Wisconsin Department of Transportation

Proposal #01: 1003-10-76, WISC 2017 397
Illinois State Line - Madison
Woodman Road to STH 11
IH 39
Rock County

1003-10-81, WISC 2017 398
Illinois State Line - Madison
Hart Road to Woodman Road
IH 39
Rock County

This is Addendum No.02, which provides for the following:

Addendum No. 02
ID 1003-10-76
Added Sheet 29A
August 3, 2017

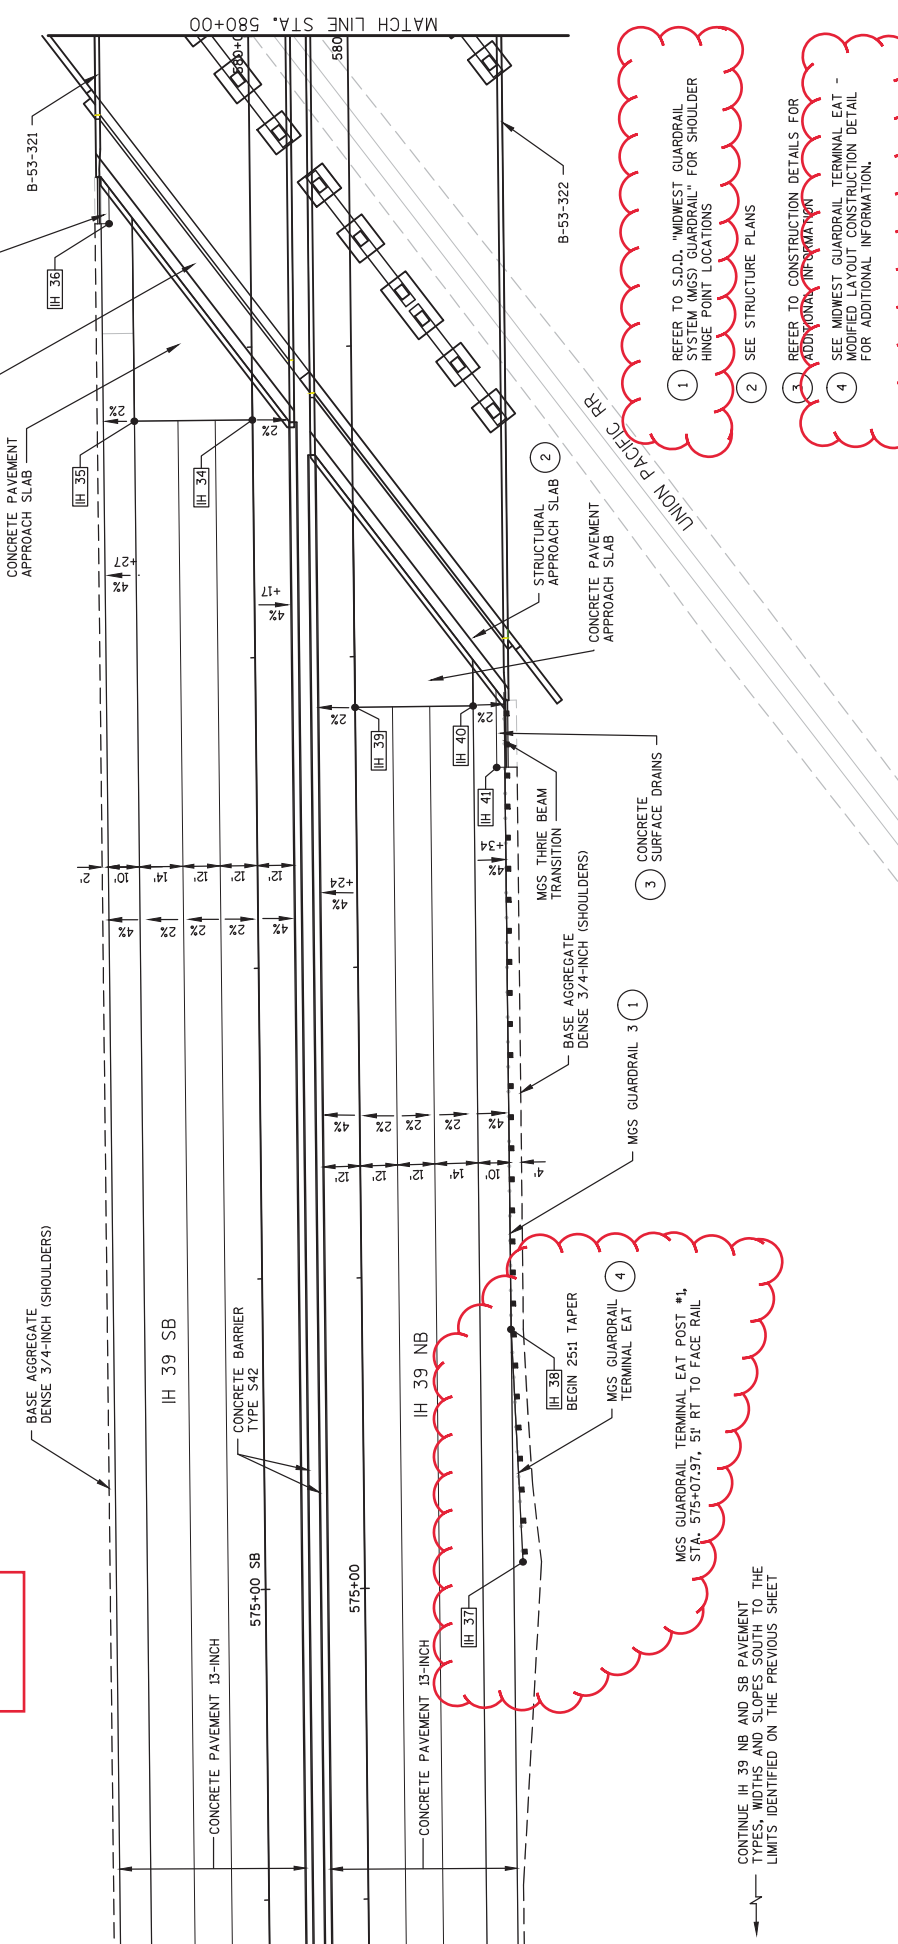
Added Plan Sheets	
Plan Sheet	
1003-10-76	
29A	Construction Details: Midwest Guardrail Terminal EAT - Modified Layout
1003-10-81	
24A	Emergency Access Ramp Typical Section
49A	Construction Details: Midwest Guardrail Terminal EAT - Modified Layout
467A	Emergency Access Ramp Quantities
510A	Emergency Access Ramp Plan & Profile
1027A – 1027L	Emergency Access Ramp Cross Sections

Addendum No. 02
ID 1003-10-76
Revised Sheet 34
August 3, 2017

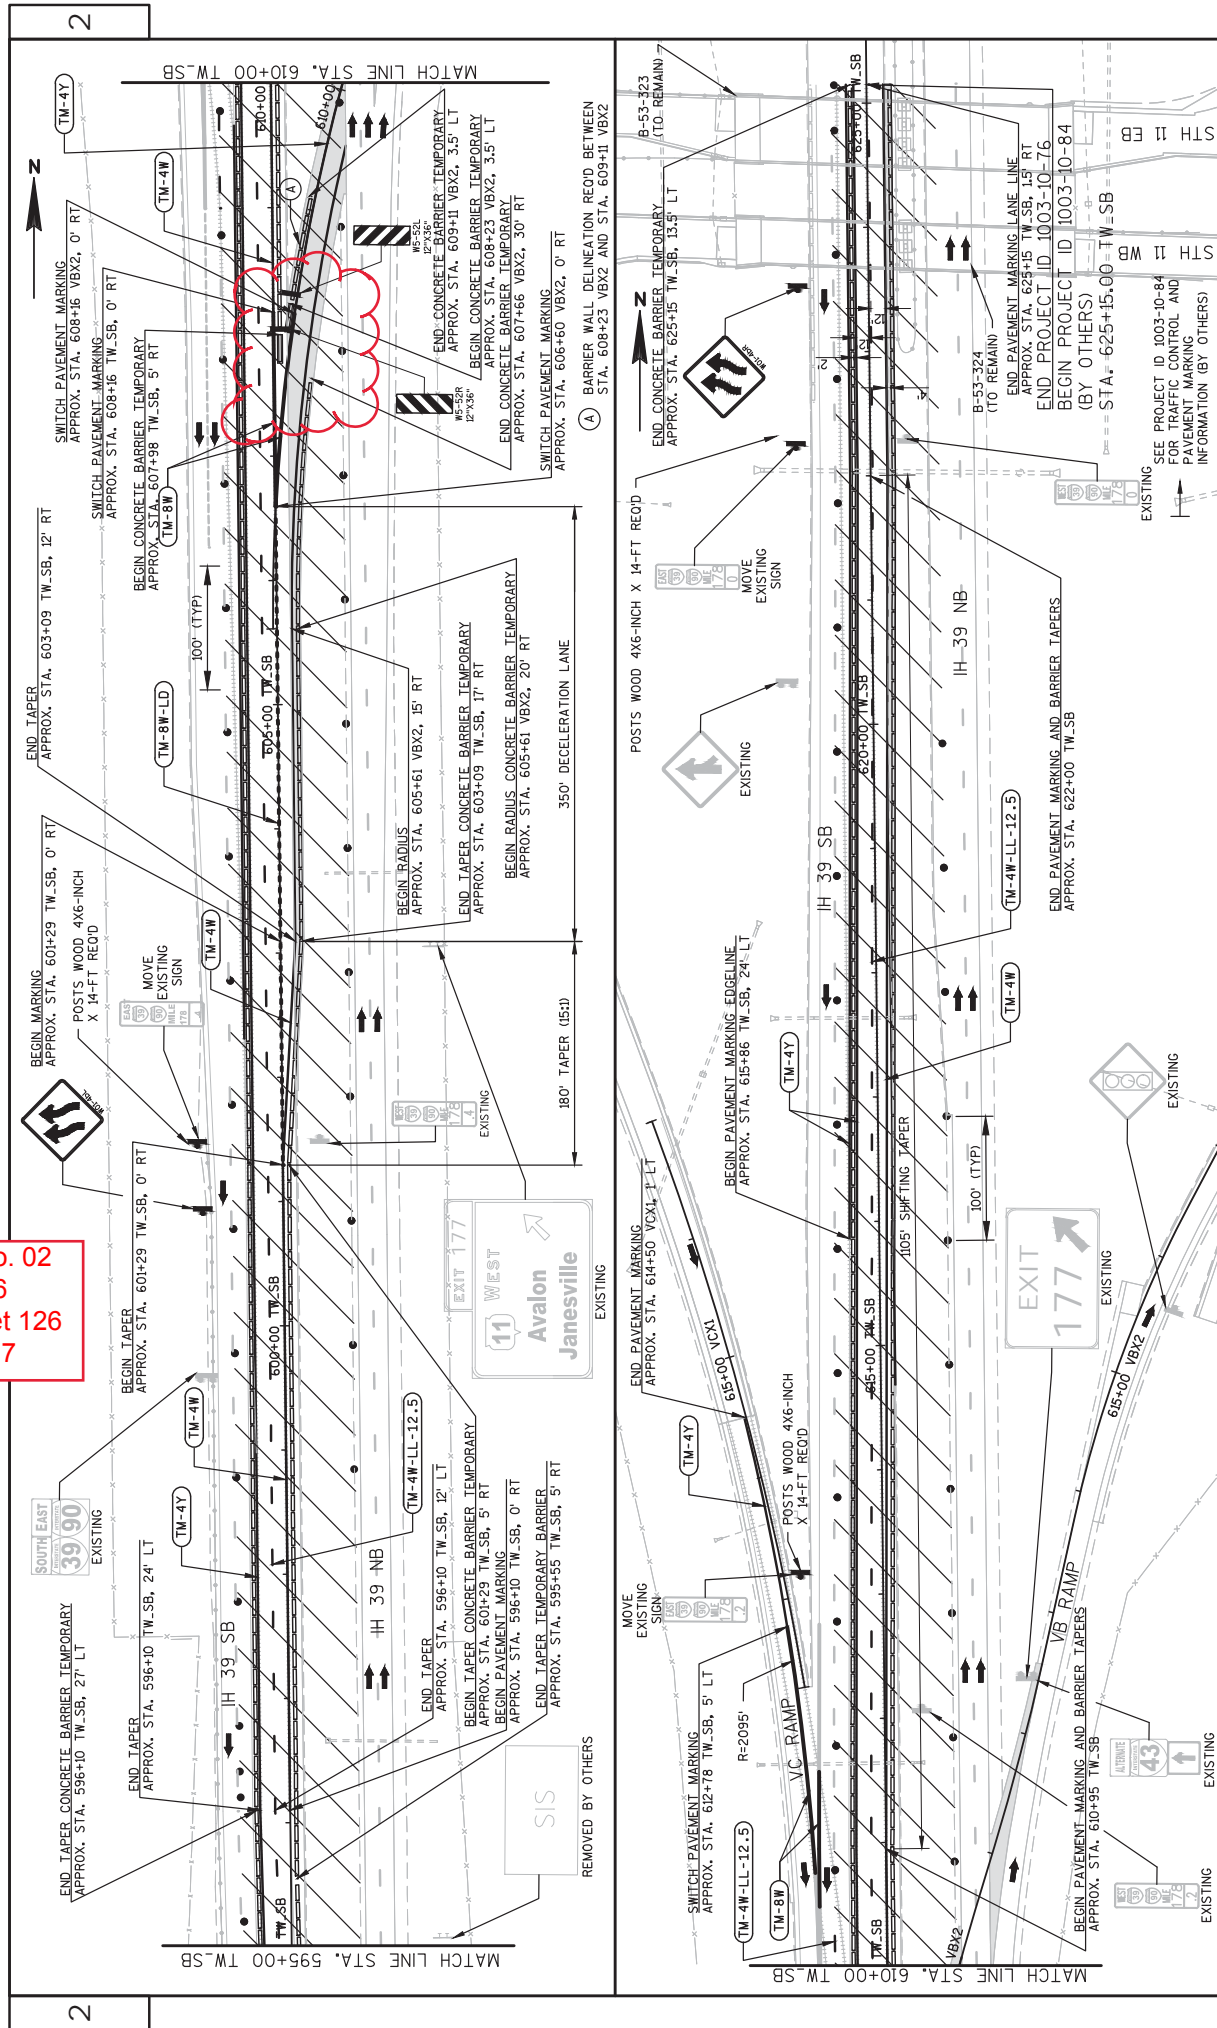
Revised Plan Sheets	
Plan Sheet	Plan Sheet Title (brief description of changes to sheet)
1003-10-76	
34	Beam Guard update
126, 136	Revised type of Crash Cushion
184	Revised Concrete Barrier Quantity
190	Revised Crash Cushion Quantity
373, 409	B-53-321 & B-53-322 Structure Plans: Deleted the bid item 550.0010 pre-boring unconsolidated materials.
502-505	Cross Section update
1003-10-81	
81, 84	Revised Guardrail
274	Revised Pullout detail
301, 323, 331	Revised type of Crash Cushion
425	Select Crush Quantity Update
449	Revised Beam Guard Quantity
452	Revised Crash Cushion Quantity
848-849, 855-857	Revised Cross Sections

Addendum No. 02
ID 1003-10-76
Revised Sheet 373
August 3, 2017

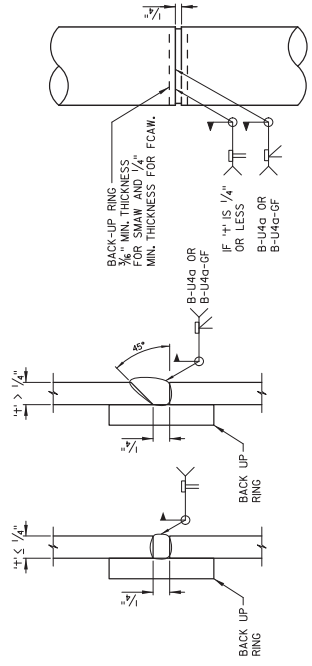
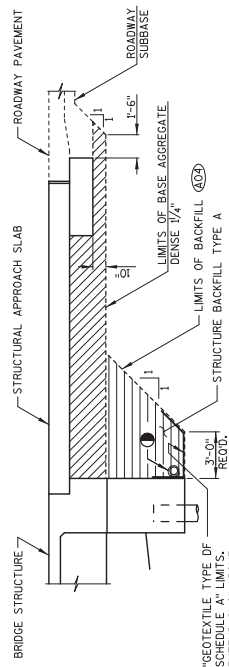
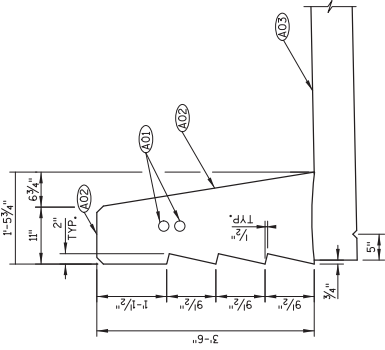
NO.	DATE	REVISION	BY
1	7-27-17	PRE-SUBMIT UNCONSOLIDATED MATERIAL	CAB
		BID ITEM REMOVED

Addendum No. 02
ID 1003-10-76
Revised Sheet 409
August 3, 2017

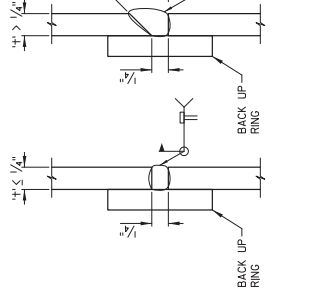
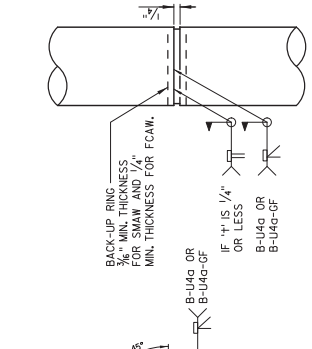
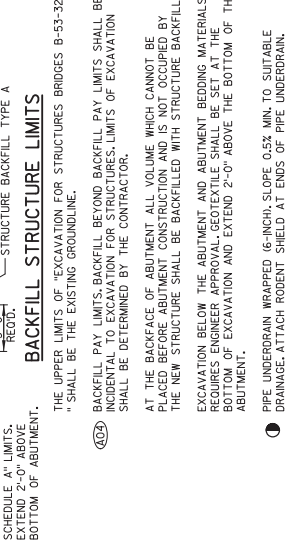
1	7-27-17	PRE-EMING UNCONSOLIDATED MATERIAL	CAB
NO.	DATE	REVISION	BY
STATE OF WISCONSIN DEPARTMENT OF TRANSPORTATION			
STRUCTURE B-53-322			
DESIGNED BY	INVESTIGATED BY	APPROVED BY	DATE
	KAM	JKR	KRH/CAB
QUANTITIES AND DETAILS			SHEET 3 OF 36
			409
